LAPP, the 21th of May 2002.

*This note reviews the inspection of the **ECAL engineering model** performed at LAPP the 15th of May 2002 on delivery of it, with the presence of representatives of IHEP (Beijing). This detector was shipped from Beijing to CERN at the end of April 2002, and then moved to LAPP.*

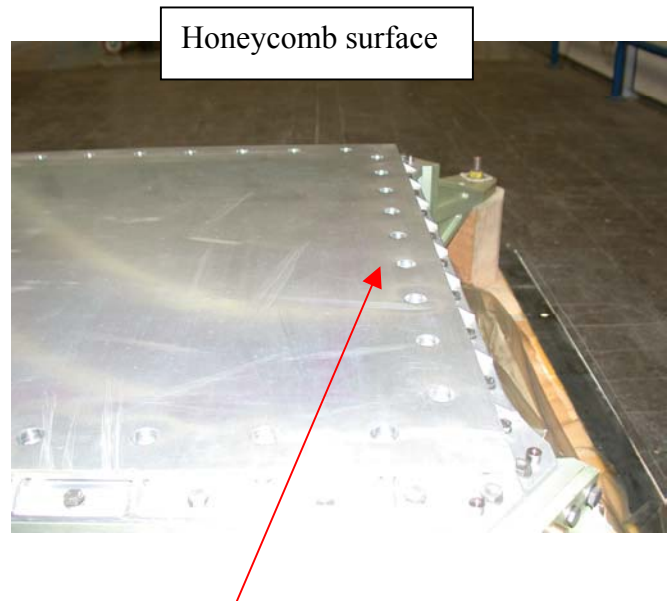
From the measurement of the thickness of the honeycomb compressed, there is some concern about how well the pancake is maintained inside the structure. If the pressure on the pancake from the spring foam is not sufficient, the pancake could move in an uncontrolled way inside the mechanical structure during the space qualification tests.

Honeycomb flatness:

no important central deflection occurred (less than 0.2 mm). The only small deflection is near the connexion (gluing) with its aluminium frame.

Spring foam position: as mentioned in the section on visual inspection, the spring foam is not correctly positioned on the lateral panel in some of the PMT holes. The **centring defect** was measured to be between 0.5 mm and 1 mm in some holes) which need to be fixed before mounting the light collection system.

Spring foam overrun

Small deflection at the frame interface with the aluminium foil

4. Check of ECAL Weight

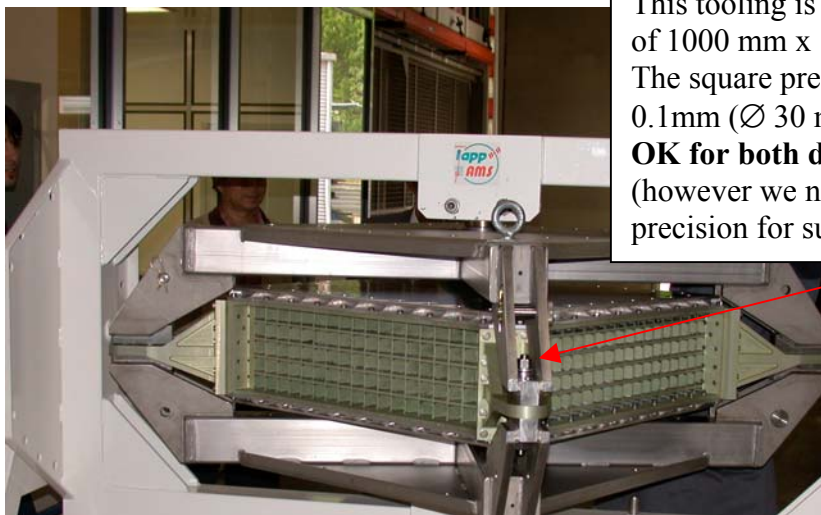
Display in ton

The Ecal weight including supporting structure (Lateral panels, brackets, honeycombs, bolts, screws, shearing pins, spring foams) and pancake has been measured by using a weighing machine displaying the result in tons. According to the oscillation between 560 Kg and 570 Kg a weight close to **565 Kg** can be assumed (to be confirmed by a weighing of each piece)

For the whole ECAL, the estimate must include in addition the weight of the light collection system which is assembled after the primary assembly.
